PRIUS

OUTLINE OF NEW FEATURES

The following changes have been made for the new Prius.

► Transition of Power Mode **◄**

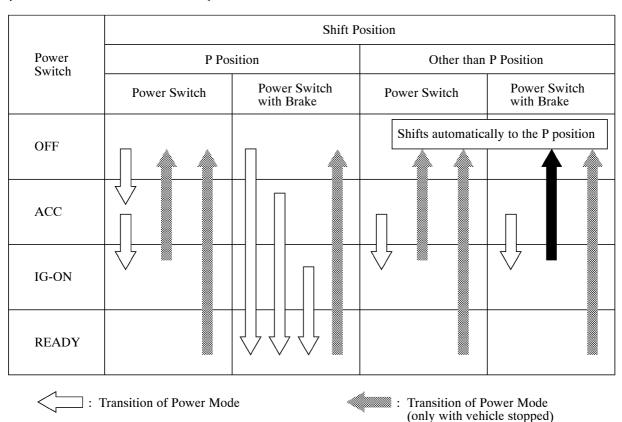
1. Push Button Start System

The program has been partially changed to improve startability.

- If the driver releases the brake pedal immediately after the system starting conditions have been met (the shift lever is in the P position, the POWER switch is pressed with the brake pedal depressed), the system holds the starting permission signal for about 1.2 seconds.
- A function that automatically turns the power mode OFF and returns the shift position to the P position when the starting operation (the POWER switch is pressed with the brake pedal depressed) is performed while the power mode is IG-ON and the shift position is in a position other than P, has been added.
